G.168
Implementors'
Guide

**Implementors' Guide for G.168 (2007-01) "Digital
network echo cancellers"**

This document contains technical corrections and clarification for the implementation of ITU-T Recommendation G.168 (01/2007).

Section 6.4.2.11.3 Test No. 10C: Canceller operation on the calling station side during page transmission and page breaks (for further study)

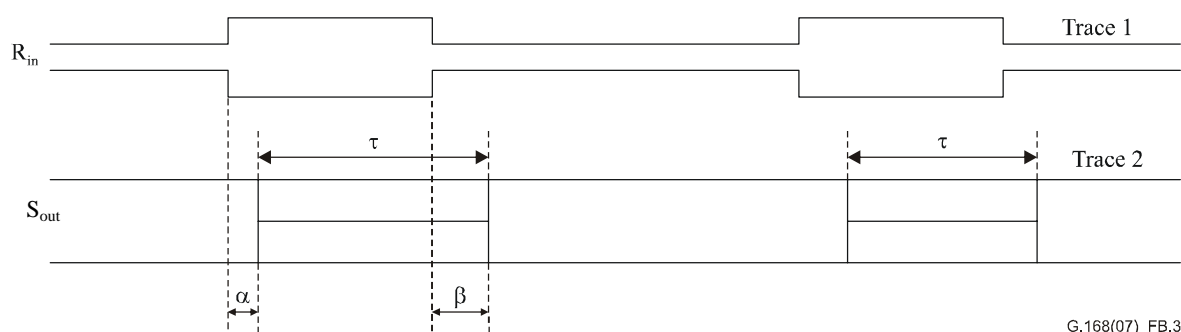
In the sixth paragraph of Section 6.4.2.11.3,

The NLP should be provisioned on during this test. ...
